NTA Observations on the Proposed Scheme Submissions and CPO Objections

Liffey Valley to City Centre Core Bus Corridor Scheme

National Transport Authority

26th October 2022

Figure 2-9: Extract from the Landscaping General Arrangement displaying trees lost at Mount Brown

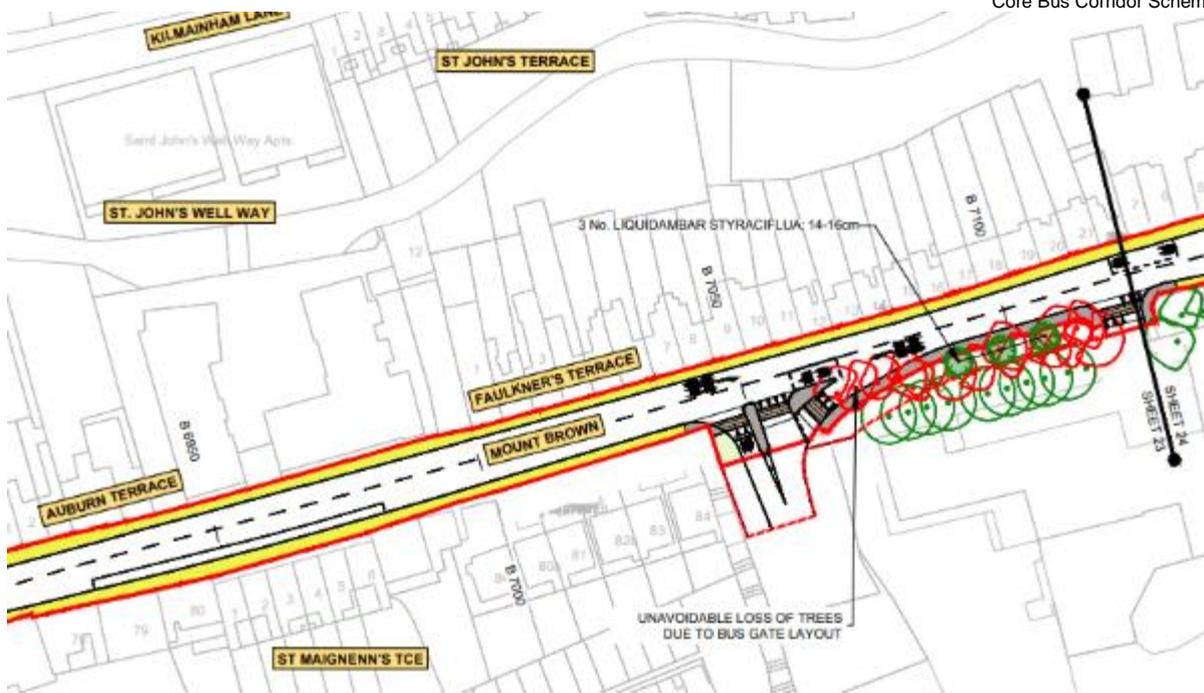
Figure 2-9, which is an extract of Landscaping General Arrangements displays the trees lost as a result of the Proposed Scheme at Mount Brown.

Figure 2-17: Cornmarket area displaying the changes in parking and bus stops.

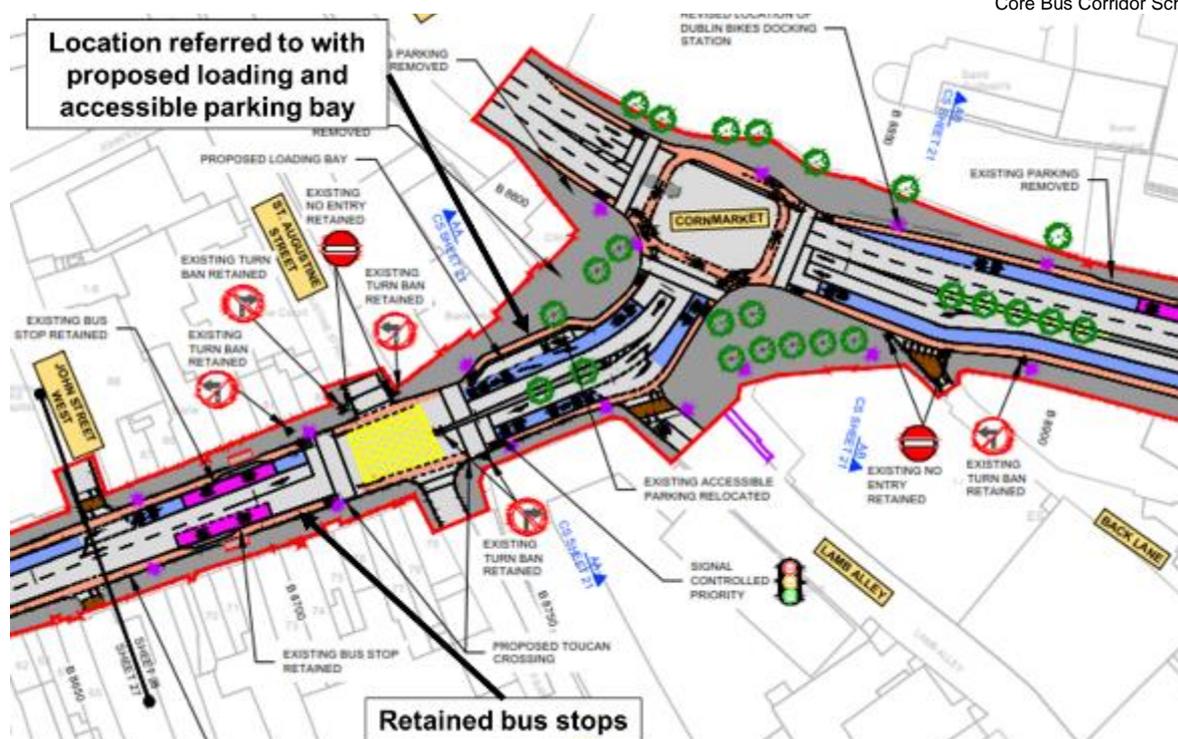
The statement that buses will be stopping / departing from a bus stop outside the respondent's apartment appears to be a misunderstanding of the proposals. It is proposed for the bus stops at Cornmarket (such as bus stops 1938, 1999, 2001 and 1937) to be retained at their current locations. It is proposed for a loading bay and disabled parking bay to be relocated to the location referred to by the respondent as shown in Figure 2-17.

Figure 2-21: Extract from Landscape General Arrangement Drawings

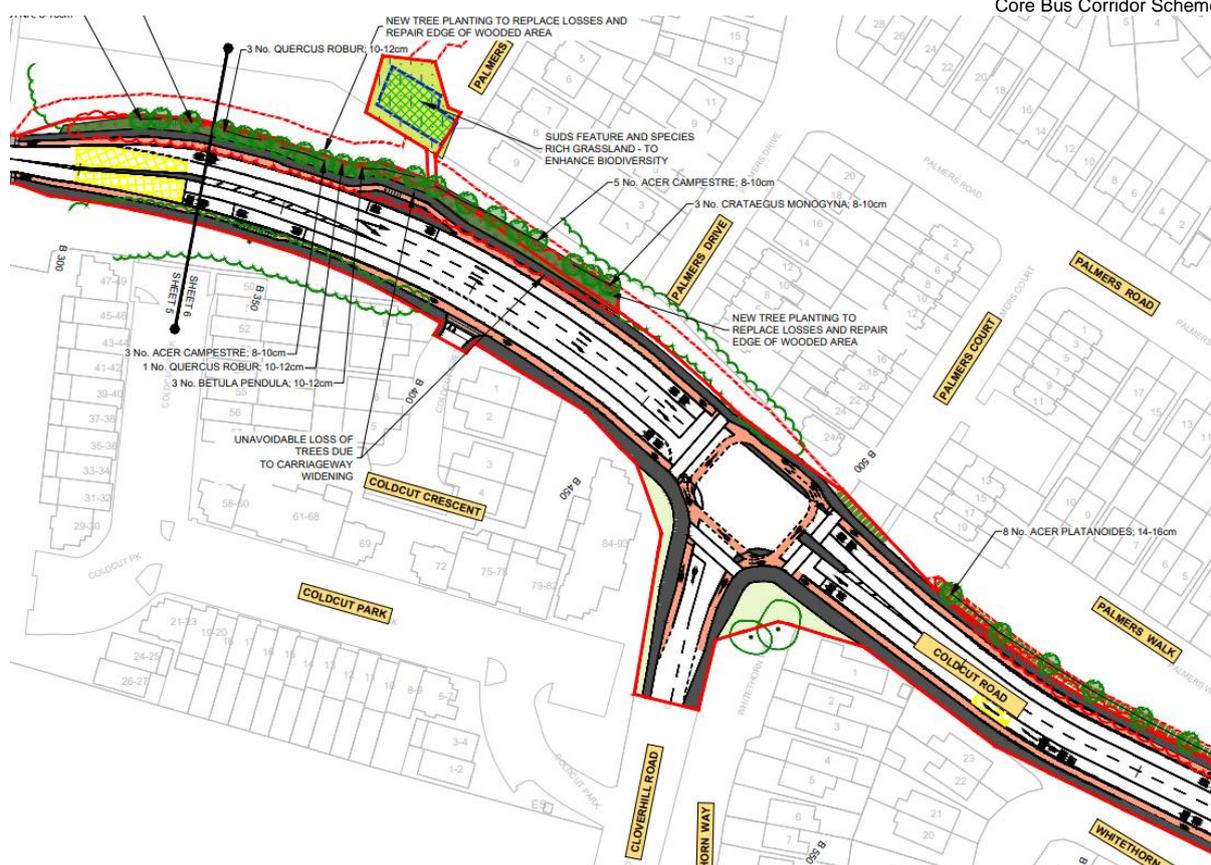
As set out in the response in Section 2.3.3.1 and displayed in the Landscape General Arrangement Drawings in Volume 3, Chapter 4 Section 5 of the EIAR, the boundary wall will be reinstated and where trees are removed, new tree planting will be provided. The reinstated boundary wall and trees are displayed in Figure 2-21.

Figure 2-27: Proposed plans at Sarsfield Road, Inchicore Road and Grattan Crescent.

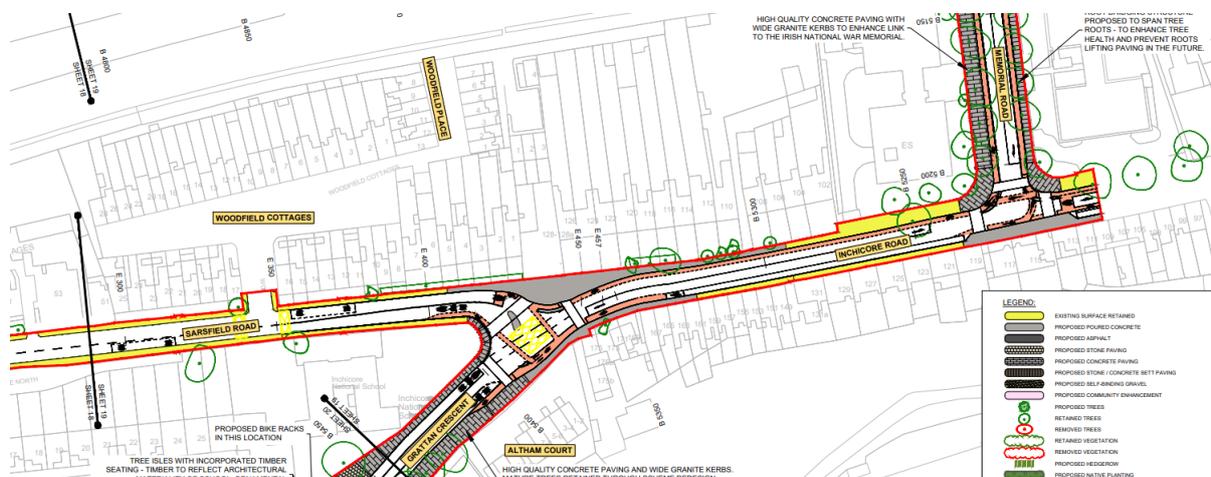
As displayed in Figure 2-27, it is proposed to retain the existing surface along the majority of Sarsfield Road (Woodfield Terrace) and Inchicore Road. At the junction of Sarsfield Road (Woodfield Terrace) / Inchicore Road / Grattan Crescent it is proposed to use poured concrete. At this location, the existing granite kerbs between properties 1-5 (which form part of the junction redesign) are proposed to be incorporated into the design, where practicable.

Figure 2-28: HGV Swept path analysis for entrance to supermarket car park

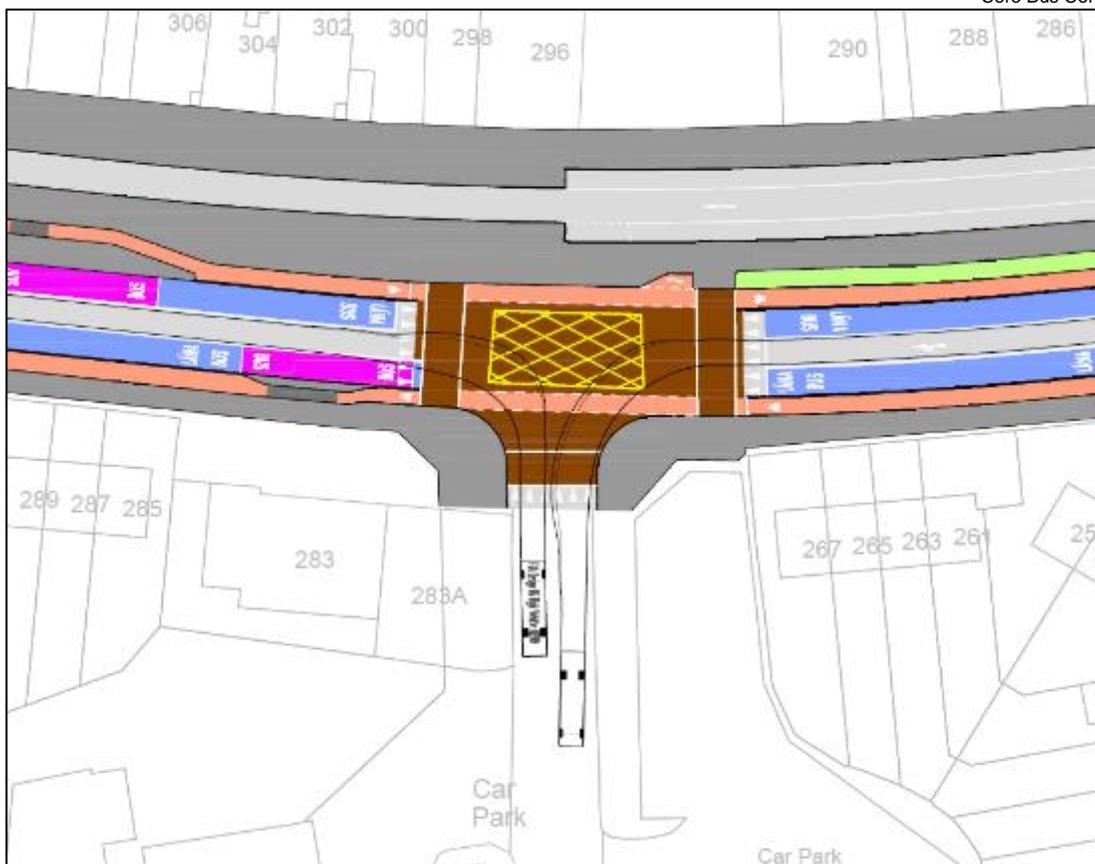
As part of the design development process swept path analyses have been undertaken at all junctions in the Proposed Scheme including this one. Figure 2-28 below shows the specific swept path analysis for the HGV movement mentioned in the submission, i.e., an approaching HGV turning from the Ballymore Road into the supermarket car park.

Figure 2-29: Example of Loading Bay

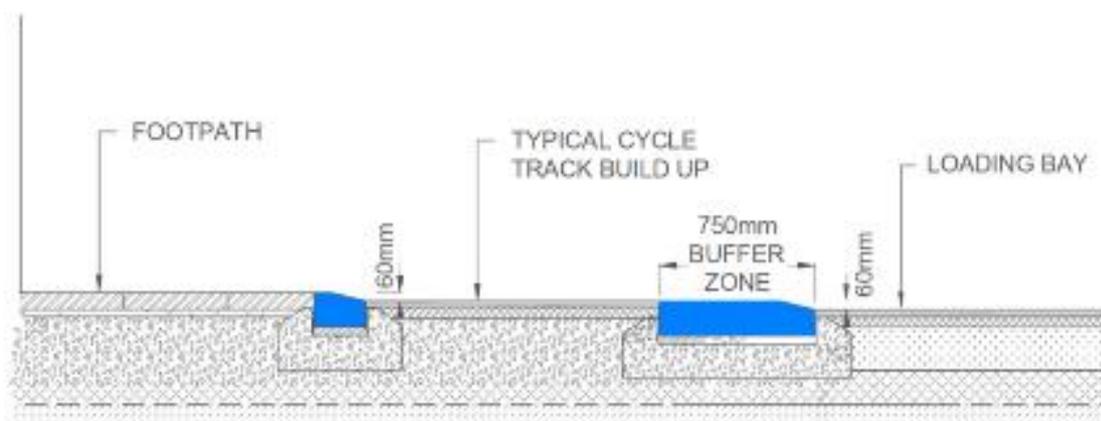
A dedicated loading bay has been provided on Thomas Street to facilitate safe loading and unloading of business. As per Appendix A4.1 Volume 4 Appendices Part 1 of 2 Preliminary Design Guidance Booklet (PDGB) of the EIAR, where loading bays are located, chamfered kerbs will be provided with a maximum height of 60mm should be used which will facilitate trolleys, pallet trucks, etc. This is displayed in Figure 2-29 which is an extract of the PDGB.

Figure 2-31: Extract of General Arrangement Sheet 19

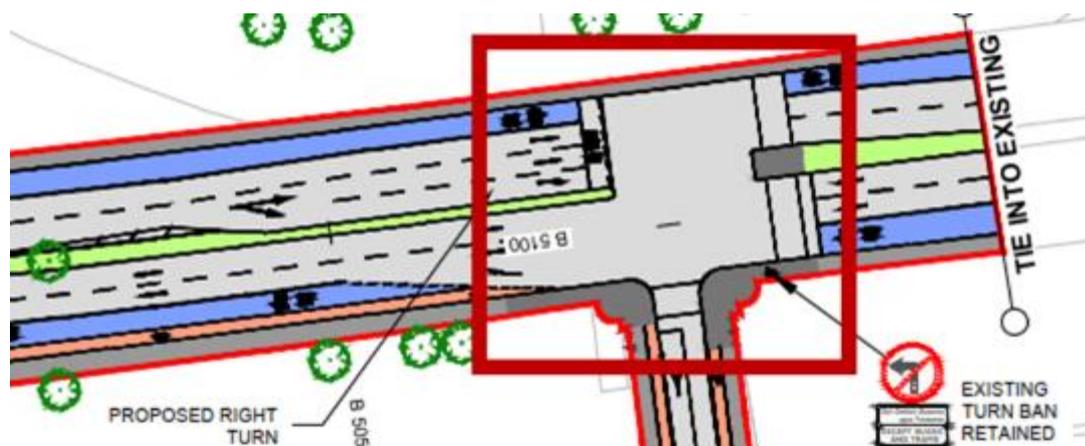
As set out in the General Arrangement drawings (EIAR Volume 3 Chapter 4 Proposed Scheme Description Figures) which are extracted in Figure 2-31 below, signalised pedestrian crossings are proposed on the eastern and southern sides of the (R148) Con Colbert Road / Memorial Road junction.

Figure 2-33: Extract of General Arrangement Sheet 20

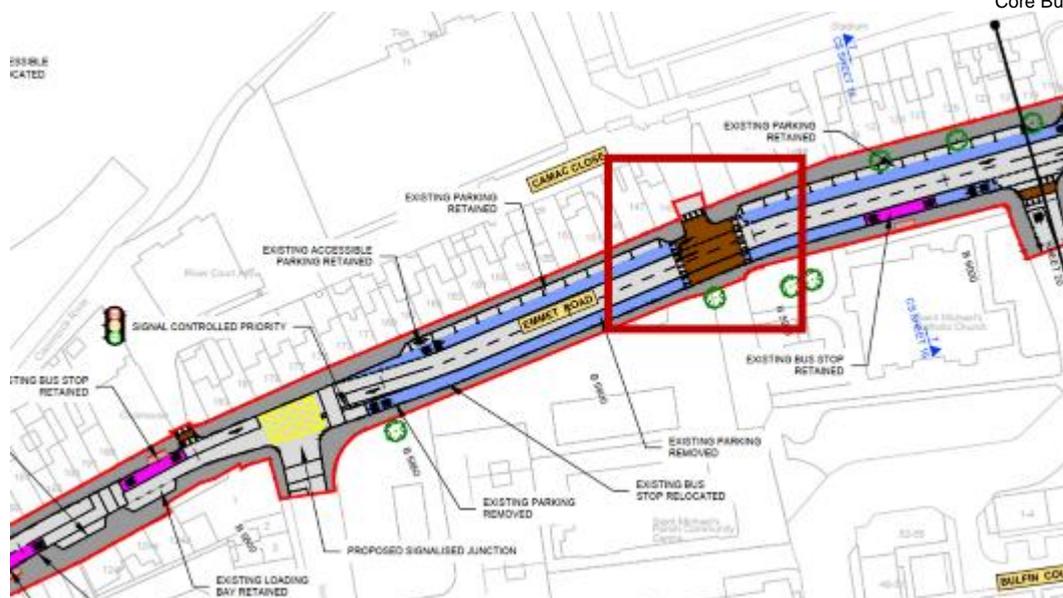
At this location it is proposed to enhance the current provision to provide a raised table across the junction, as shown in the General Arrangement drawings (EIAR Volume 3 Chapter 4 Proposed Scheme Description Figures) which are extracted in Figure 2-33 below. A signalised pedestrian crossings is proposed approximately 100m west of the St Patrick's Athletic FC Richmond Park access at the St Vincent Street West junction. Additionally, the existing mid-link crossing located approximately 100m east of the St Patrick's Athletic FC Richmond Park access to the east of Buffin Road it proposed to be upgraded.

Figure 2-38: Extract of the BCPPDGB, displaying footpath, cycle track, and bus lane arrangements.

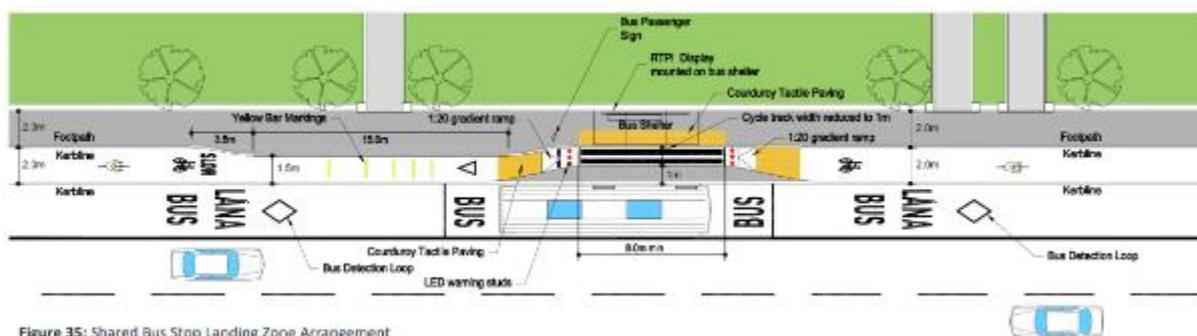
On the approach to bus stops, cycle lanes narrow and the submission states that this should narrow away from the rather than towards it. As set out in the Preliminary Design Report Section 4.13.2 provided in the Supplementary Information, the preferred bus stop arrangement for the Proposed Scheme is the island bus stop arrangement. This arrangement will reduce the potential for conflict between pedestrians, cyclists and stopping buses by deflecting cyclists behind the bus stop, thus creating an island area for boarding and alighting passengers. To facilitate this, on approach to the bus stop island the cycle track is intentionally narrowed with yellow bar markings also used to promote a low speed single file cycling arrangement on approach to the bus stop. In addition to this, at the bus stop, the cycle track should be deflected to provide a 1.0m wide boarding/alighting zone for bus passengers. Figure 2-38, which is an extract of the PDGB, displays this detail.

Figure 3-14: Proposed retaining wall plans

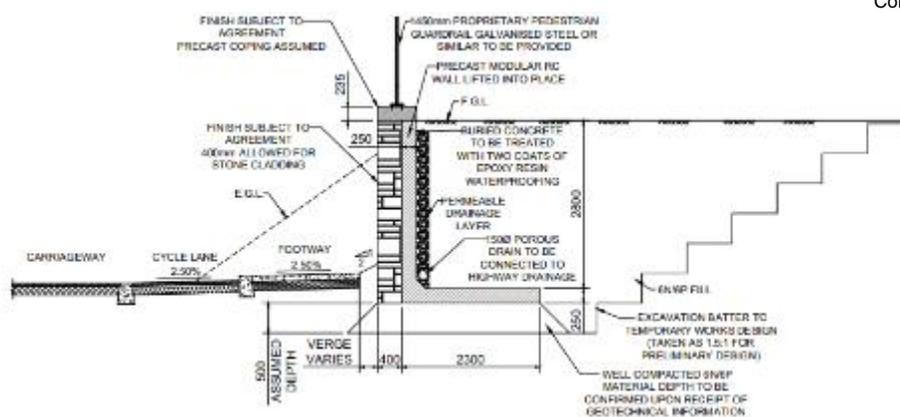
The detail of the proposed retaining wall at this location can be seen in the Structures Preliminary Design Report included as Appendix J of the Preliminary Design Report provided in the Supplementary Information.

Figure 3-16: Proposed retaining wall detail

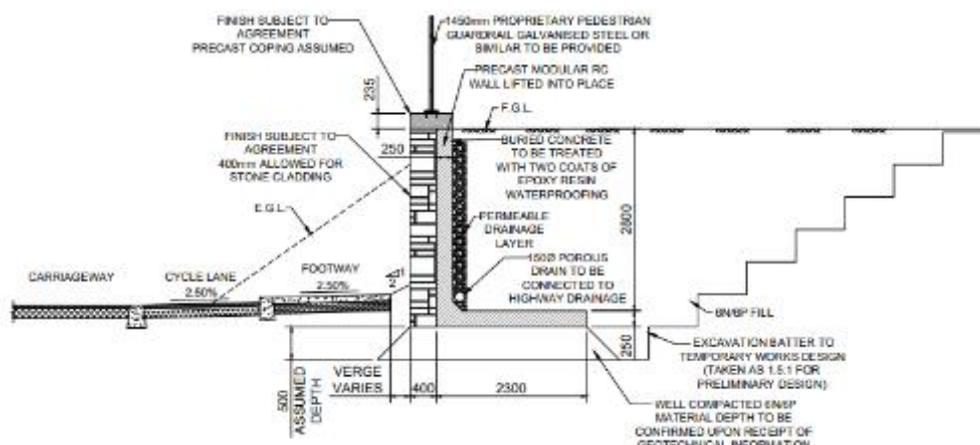
The detail of the proposed retaining wall at this location can be seen in the Structures Preliminary Design Report included as Appendix J of the Preliminary Design Report.
